**SEVENTH EXPLANATION OF SIGNIFICANT DIFFERENCES
FOR THE
NEW BEDFORD HARBOR SUPERFUND SITE
UPPER AND LOWER HARBOR OPERABLE UNIT 1 (OU1)
NEW BEDFORD, MASSACHUSETTS
U.S. EPA REGION 1**

SEPTEMBER 2025

Figure 4 – Pilot Outer Harbor Cap: 2005 and 2015 Cap Footprint Areas

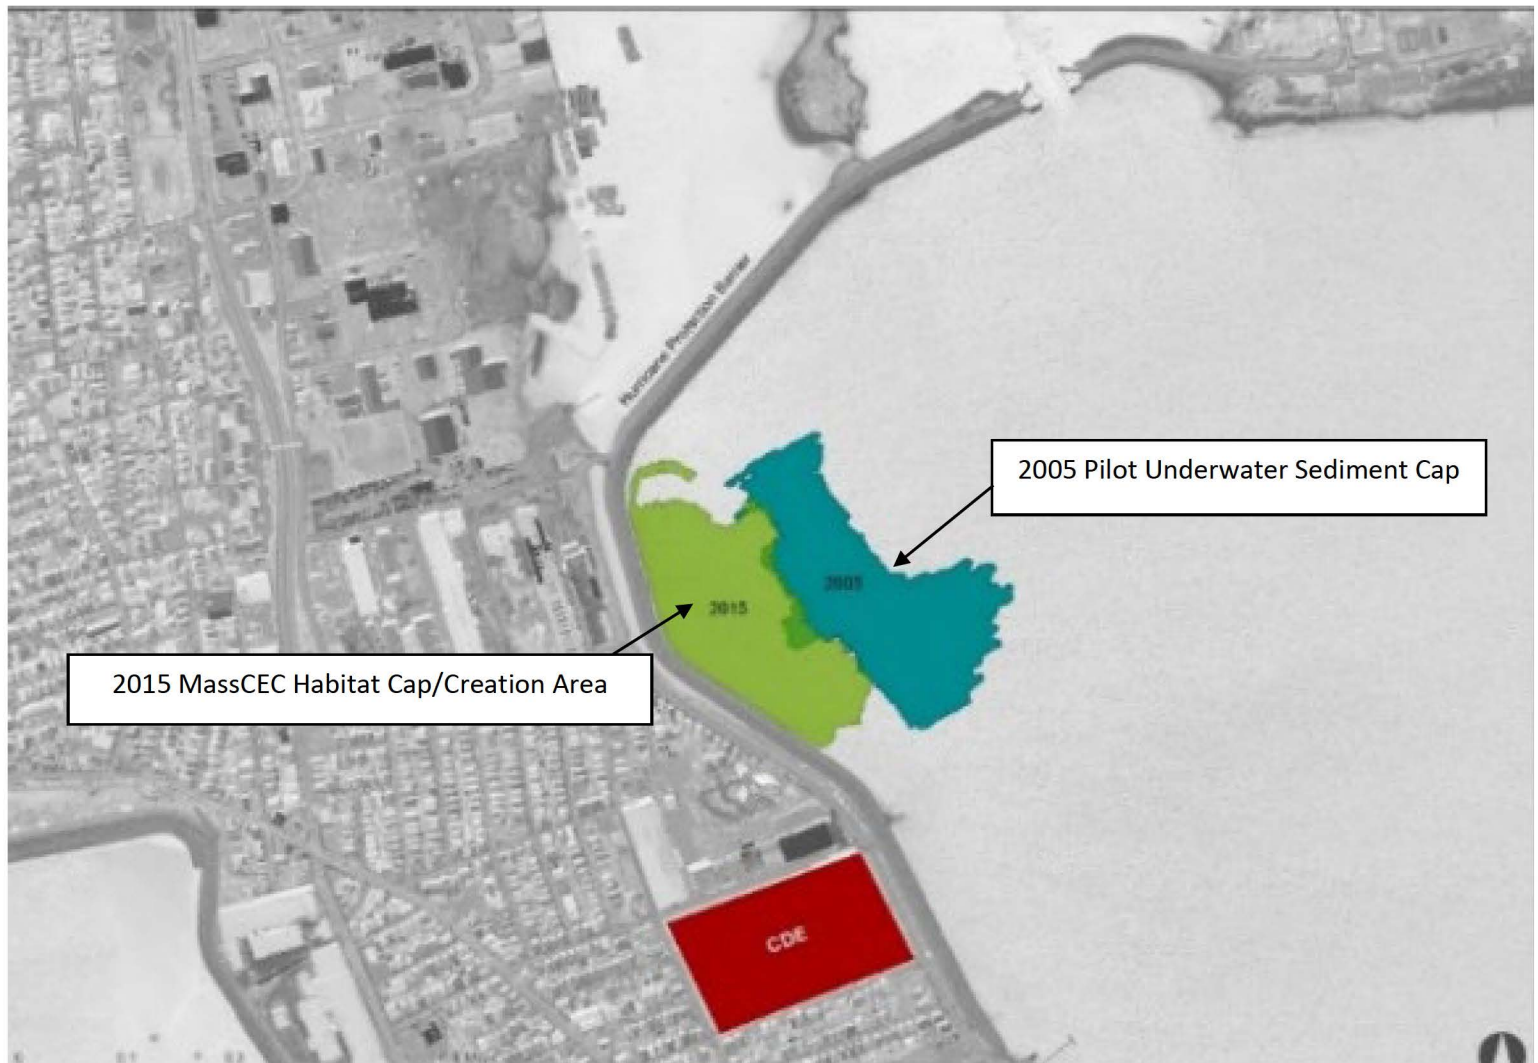
4. The Outer Harbor Pilot Cap is protective without the isolation layer since it has been monitored since 2005 using both bathymetry and sampling of PCB levels on its surface. The bathymetry surveys show that the cap is physically stable. The PCB sampling shows that the cap is functioning as designed with maximum PCB levels approximately two orders of magnitude lower post-capping than pre-capping (e.g., 1.12 ppm versus 94 ppm).

(note that only the 2005 cap area is addressed by this ESD)
